UNITED STATES PATENT AND TRADEMARK OFFICE

| APPLICATION NO. | FILING DATE | FIRST NAMED INVENTOR | ATTORNEY DOCKET NO. | CONFIRMATION NO. |
|-----------------------------------------------------------------------|-------------|----------------------|--------------------------------|------------------|
| 10/078,601 | 02/19/2002 | Xiaoming Ren | 107044-0013 | 5541 |

Office Action Summary

DETAILED ACTION

FIG. 5

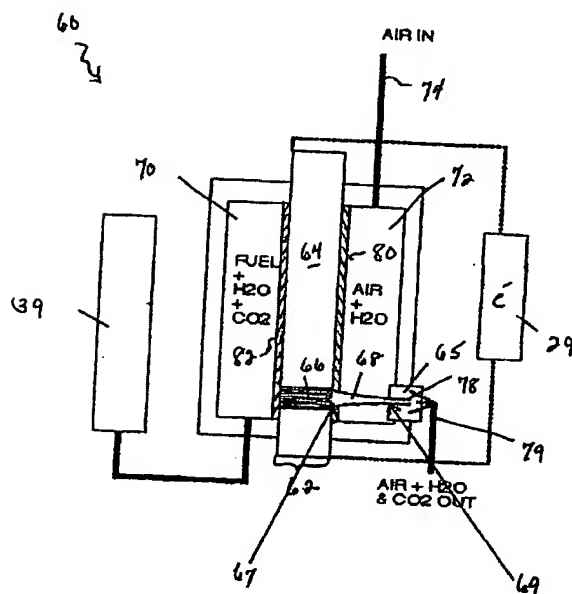
Figure 5 below depicts a passive control system using gas produced in the anode chamber for removing water from the reactive sites in the cathode chamber (SECTION 0085) wherein the CO₂ is vented out or released to the ambient environment (FIGURE 5).

As apparent from Figure 5 and Corey et al's disclosure of SECTIONS 0014, 0017 and 0020), this fuel cell system: i) can be provided with a gaseous effluent port located in the anode chamber in close proximity to the anode side of the membrane electrolyte; and ii) does not have any liquid exit port in the anode chamber per se. Thus, it has a liquid closed volume anode

chamber, and no anode liquid recirculation. These features act as a gaseous anodic product removal component. This structure also encompasses the absence of any water external pumping and/or active water removal element.

As previously mentioned, the fuel cell system of **Figure 5** above represents a passive fuel cell system (SECTION 0085). *Thus, it operates without external pumping of cathodically-generated water and without active water removal elements.*

FIG. 5

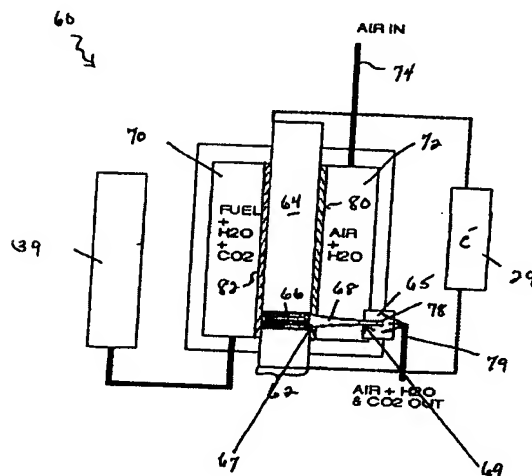
source and said anode aspect of the direct oxidation fuel cell for controlling the delivery of fuel to the anode aspect of the membrane electrolyte". In view of that and given that the prior art of record clearly teaches: that the effluents could be removed by venting the carbon dioxide out of the anode chamber (Corey et al SECTION 0014); as well as an effluent gas produced in an anode chamber of a fuel cell is collector and then exhausted through a cathode chamber of the fuel cell (Corey et al SECTION 0020); having the carbon dioxide produced from the oxidation of fuels not directly exhausted from the fuel cell system but, instead, used to remove/recirculate effluent water in the cathode (Corey et al SECTION 0017); and the fuel cell including a proton conducting membrane electrolyte separating the chambers and having an effluent gas-permeable portion allowing effluent gas produced in said anode chamber to flow into the cathode chamber (Corey et al SECTION 0026); in addition, Figure 5 clearly illustrates the CO₂ being vented out or released to the ambient environment:

thus, Corey et al clearly envisage having the gaseous effluent generated in the anode portion of the fuel cell vented out of the anode portion and into the surrounding ambient atmosphere; and having a delivery element for feeding fuel into the anode aspect of the membrane electrolyte. As

apparent from Figure 5 and Corey et al's disclosure of SECTIONS 0014, 0017 and 0020), this fuel cell system: i) can be provided with a gaseous effluent port located in the anode chamber in close proximity to the anode side of the membrane electrolyte; and ii) does not have any liquid exit port in the anode chamber per se. Thus, it has a liquid closed volume anode chamber, and no anode liquid recirculation. These features act as a gaseous anodic product removal component. This structure also encompasses the absence of any water external pumping and/or active water removal element. Hence, it is emphatically asserted that the prior art of record still provides both the necessary functional and structural interrelationship to satisfy the claimed requirement.
